# **TMS320DM816x DaVinci Digital Media Processors Revisions 2.0, 1.1, 1.0**

## **Silicon Errata**

Literature Number: SPRZ329B  
March 2011–Revised February 2012

**Figure 3. ACTVID Signal Active for All Lines of Incoming Data**

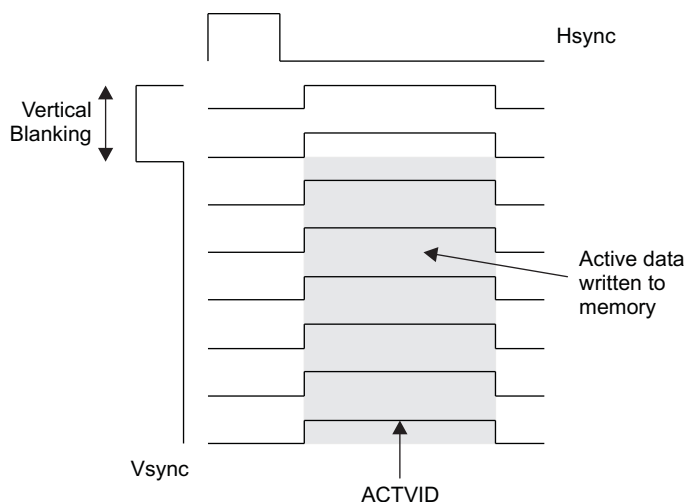
**Details:** The VIP port supports a discrete sync capture mode where the ACTVID signal is used to determine the active region of the video and then the VPDMA writes this active video frame to memory. However, with some external video decoders, this mode does not work by default.

**Workaround:** The VIP parser requires that the ACTVID signal is active for all lines of the incoming data, including the vertical blanking region. The vertical blanking region, itself, is not written to memory by the VPDMA. [Figure 3](#) illustrates this.

**Figure 4. SATA Activity LED Connectivity**

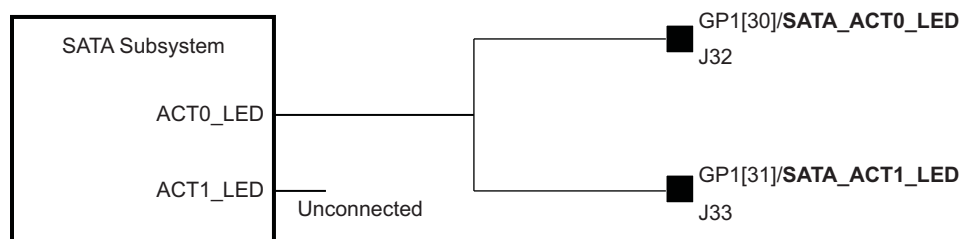
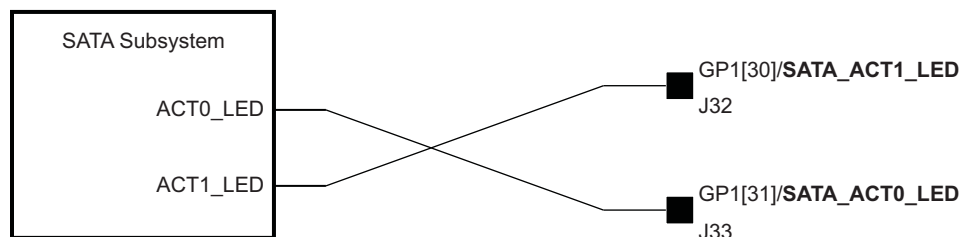
This issue is corrected on revision 2.0, but with the output pins reversed. SATA\_ACT1\_LED is mapped to pin J32 and SATA\_ACT0\_LED to pin J33 (see [Figure 4](#)).
